SUBSURFACE WASTEWATER DISPOSAL SYSTEM APPLICATION

Town Or Plantation	Augusta
Street Subdivision Lot #	Route 105

Last: Shaw First: Ernie

SUBSURFACE WASTEWATER DISPOSAL PLAN

SUBSURFACE WASTEWATER DISPOSAL PLAN

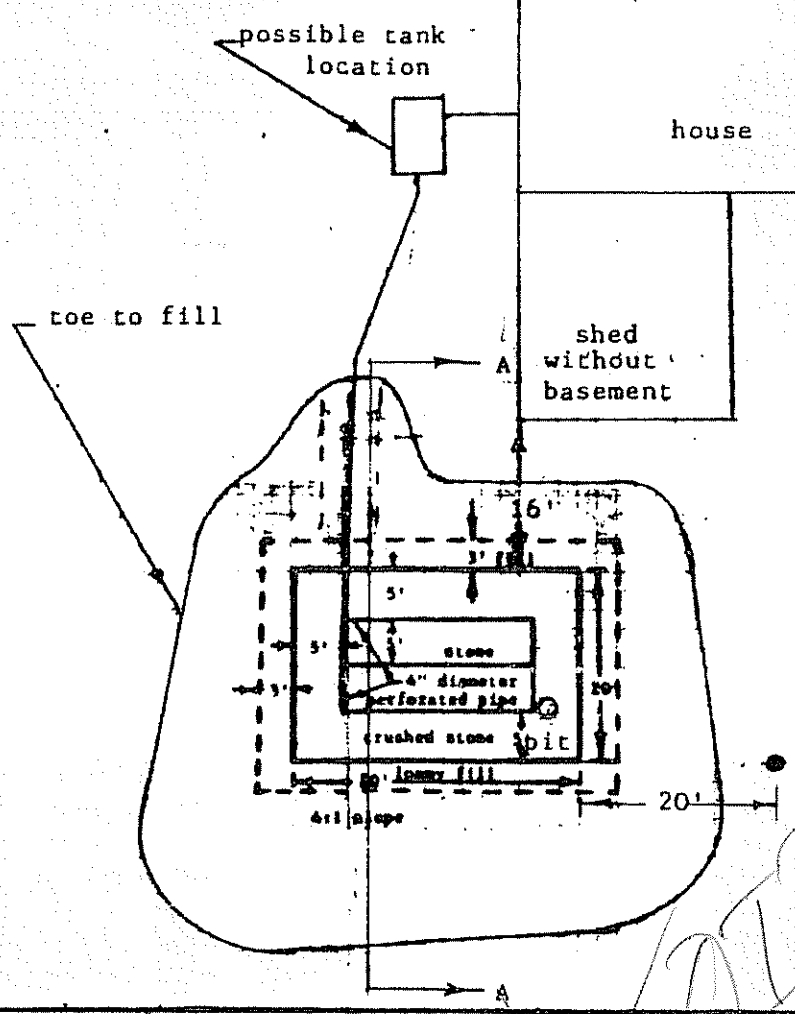
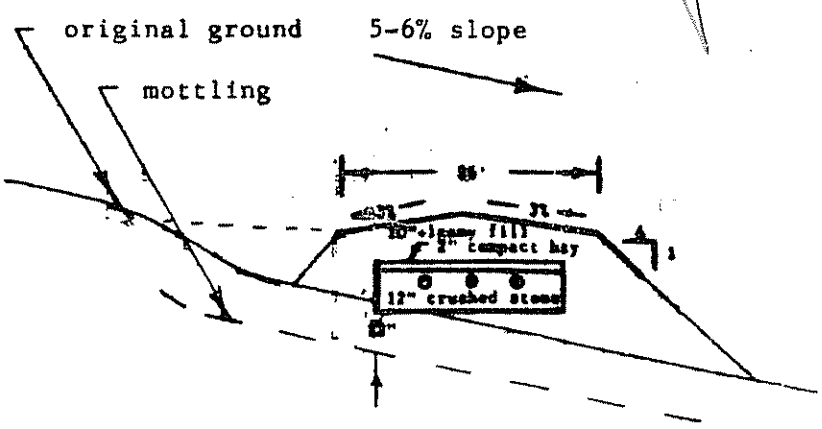
DID this sheet

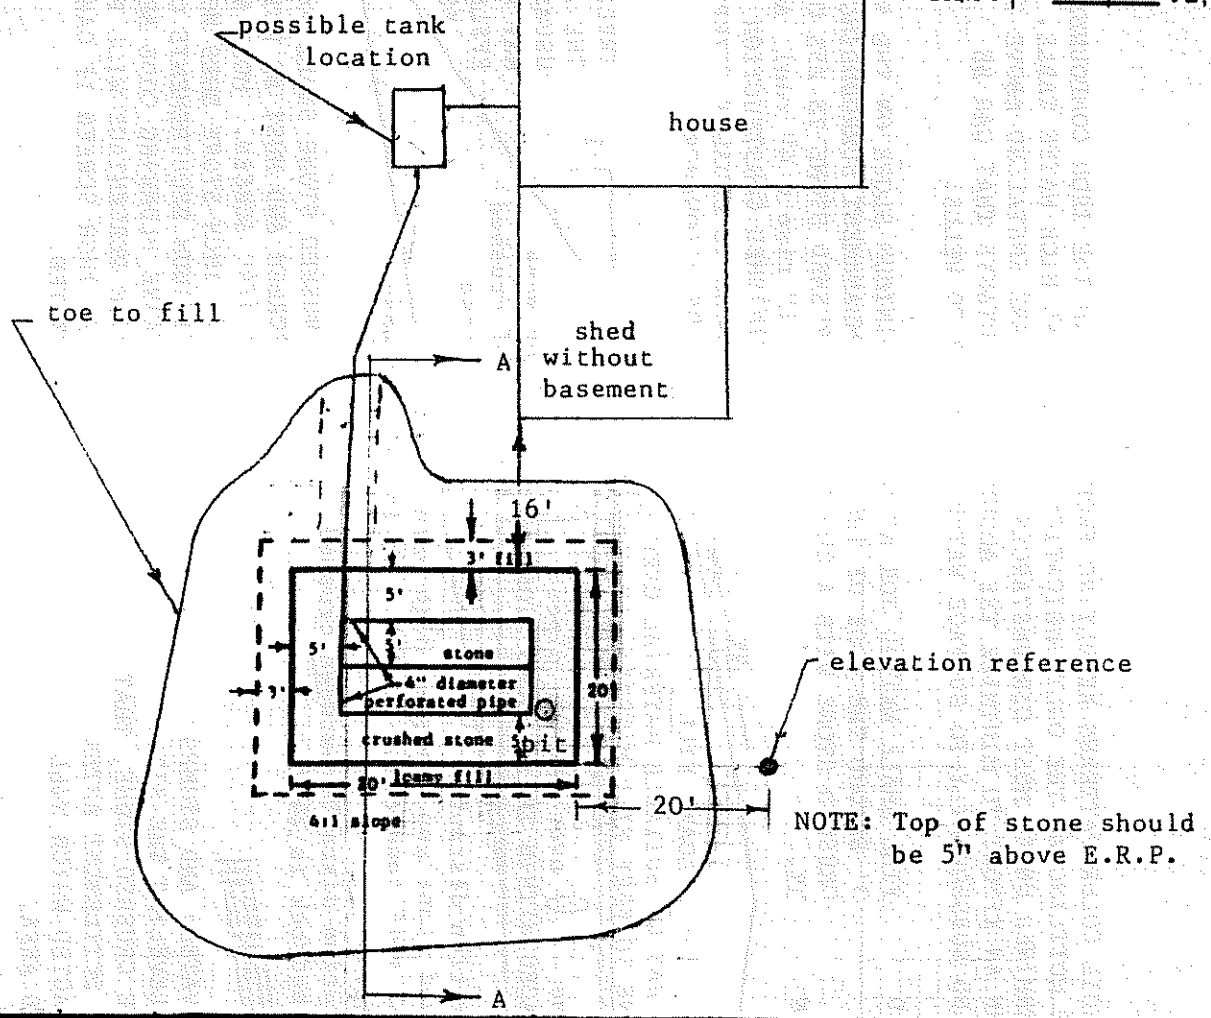
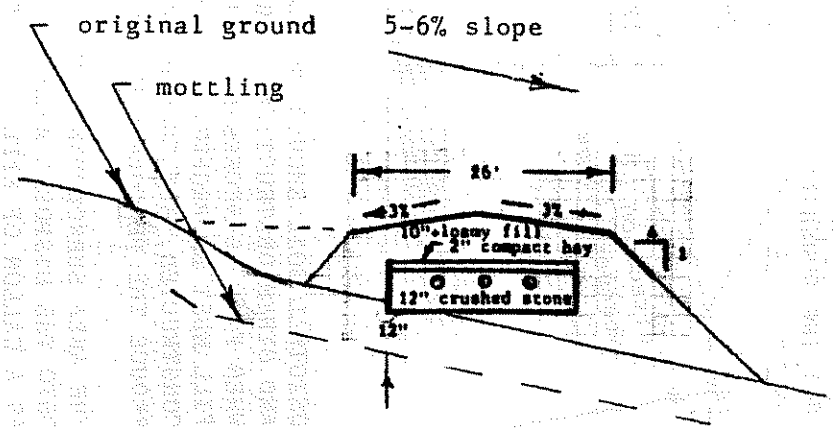
NOTE: Top of stone should be 5" above E.R.P.

revised August 7, 1986
May 9, 1985
Date

FILL REQUIREMENTS		CONSTRUCTION ELEVATIONS		ELEVATION REFERENCE POINT LOCATION & DESCRIPTION
Depth of Fill (Upslope)	21"	Reference Elevation is	100' 00"	nail in base of tree
Depth of Fill (Downslope)	35%33"	Bottom of Disposal Area	99' 05"	
		Top of Distribution Lines or Chambers	100' 04"
